Terminal A Extension Project

Response to CRS-0002 - Application Review - Information Request - Pile driving effects to fish and marine mammals

August 2015

Figure 1. 1/3-octave band per-pulse SEL for (left) 10 m and (right) 500 m range from the source

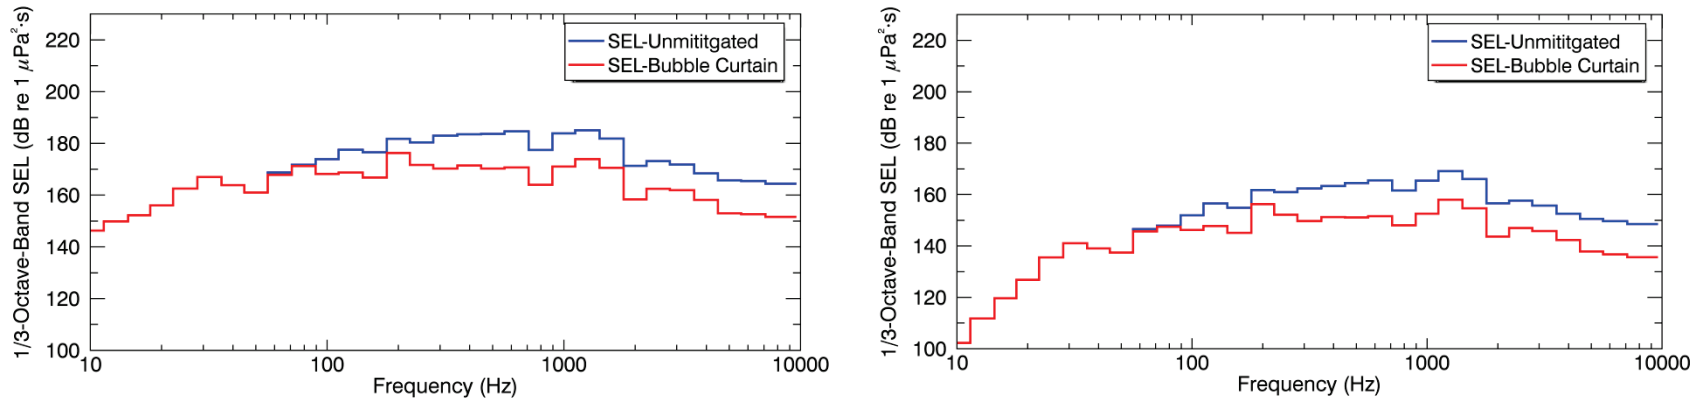
The current document addresses the requests from the reviewers of the revised report by Matthews et al. (2015). It includes threshold radii based on marine mammal injury and disturbance criteria (Southall et al. 2007) and fish injury criteria (Popper et al. 2014) for cumulative sound exposure computed over a period of 1 hour.

Per-pulse sound exposure levels (SEL) and root-mean-square sound pressure levels (rms SPL) were calculated in third-octave frequency bands for two representative distances from the source, 10 m and 500 m. Figures 1 and 2 show received band levels at the two ranges respectively, both unmitigated and mitigated with an air bubble curtain system. The acoustic propagation model used to compute these estimates, the Marine Operations Noise Model (MONM) by JASCO Applied Sciences (Hannay and Racca 2005), does not directly predict the 90% rms sound pressure levels (SPL). We derived these metrics from the modelled SEL by applying conversion factors obtained from empirical measurements of SEL and 90% rms SPL in locations with similar acoustic environments. The conversion factors from SEL to rms SPL were determined to be 15 dB at 10m and 11 dB at 500 m range. The air bubble curtain system has no perceptible mitigation effect below 63 Hz, hence the overlap of the unmitigated and mitigated levels curves for those low frequencies.
